**Response to the Notice of Disapproval for the Corrective Measures Evaluation Report for
Material Disposal Area A, Solid Waste Management Unit 21-014, at Technical Area 21,
Los Alamos National Laboratory EPA ID No: NM0890010515, HWB-LANL-08-023,
Dated January 28, 2009**

Figure 1 Climate's demand for water (PET) versus supply of water (precipitation)

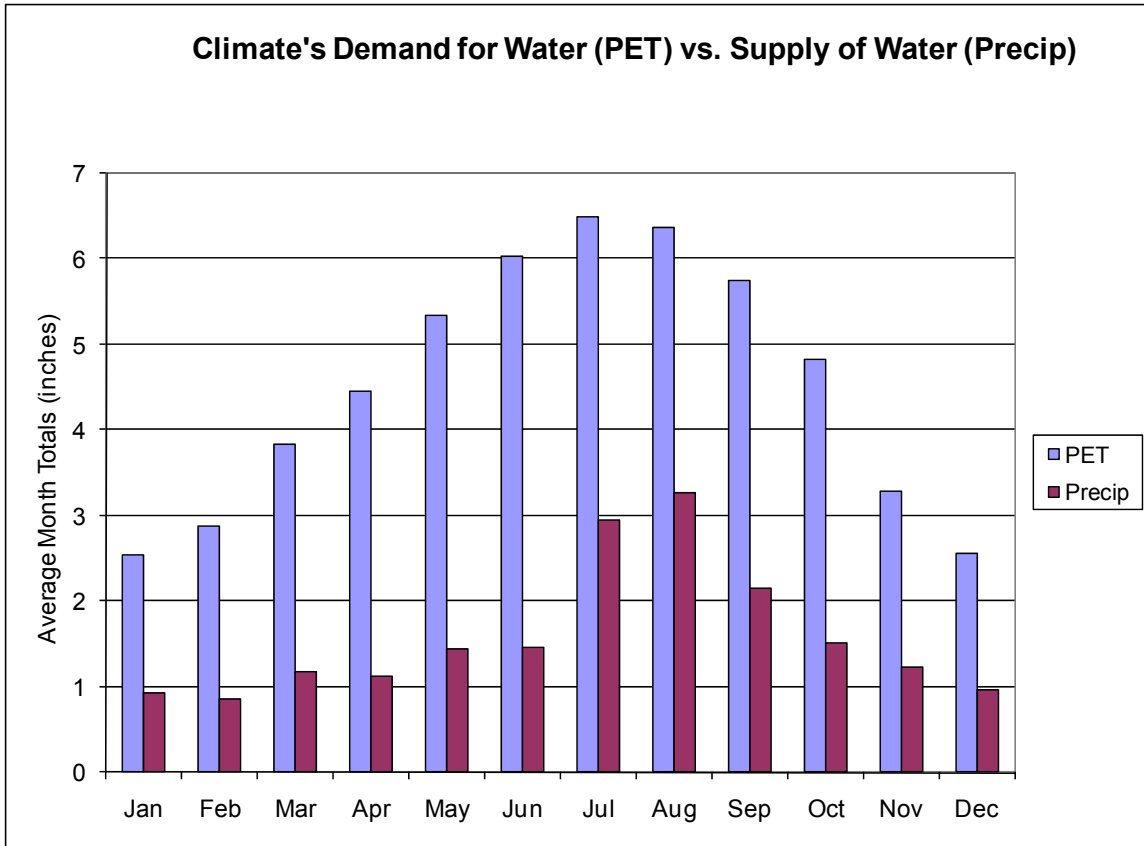
NMED Comment: While the Permittees' modeling shows VOCs are not a concern at MDA A, the monitoring results from the 2006 and 2007 show inconsistencies in detected VOC and tritium concentration. The variability of the field results makes it necessary for vapor monitoring to be a part of any corrective measure alternative for MDA A. Furthermore, NMED does not agree with the statement that, "ET caps are proven technology and do not require monitoring to demonstrate the technical effectiveness." ET caps perform well in arid and semi-arid climates, however Los Alamos is a wetter environment and snow is especially bad for ET covers. ET covers are proven to leak, thus must be monitored. The Permittees' must propose vapor monitoring locations (including BH-08) as part of the monitoring technology for MDA A. See General Comment number 6.

16. Evapotranspiration (ET) covers are a proven technology. ET covers have been monitored more than any other cover technology (<http://clu.in.org/products/altcovers/>) and have provided continued evidence that they are an excellent choice for many site closures ([http://www.clu-in.org/download/remed/epa542f03015.pdf-search='evapotranspiration epa fact sheet](http://www.clu-in.org/download/remed/epa542f03015.pdf-search='evapotranspiration%20epa%20fact%20sheet)). Although cover systems that meet the RCRA design criteria have typically received little to no monitoring, this minimal monitoring has shown they have significant problems, such as barrier layer degradation and flaws in geosynthetic membranes as well as increased VOC detection in groundwater due to the installation of impermeable cover systems. Dwyer (2003, 097902) showed that ET cover systems in New Mexico actually outperform prescriptive technologies.

ET covers are designed to store infiltrated water, including snowmelt, until that water can be removed via the combination of transpiration and surface evaporation, collectively referred to as ET. This is

predicated on the assumption that the climate demand for water at this site is higher than the actual supply of water. Potential evapotranspiration (PET) is a quantification of a site's demand for water. Dwyer et al. (2007, 096232) present a detailed explanation of this topic. The supply of water is generally via precipitation. Figure 1 depicts the monthly comparison of PET versus precipitation for Los Alamos, New Mexico. It can be seen that for every month of the year, the demand for water is significantly higher than its supply. Therefore, Los Alamos is an excellent environment for deployment of an ET cover.

The cover profile will be designed per steps detailed in Dwyer et al. (2007, 096232) that uses the combination of unsaturated modeling, applicable field data, and natural analogs to develop a conservative cover profile that should effectively isolate the underlying waste from the environment for an extended period of time. Furthermore, because the site contains some radionuclides, an ET cover system composed of earthen materials with unlimited longevity is preferred, compared with geosynthetics with limited effective life.
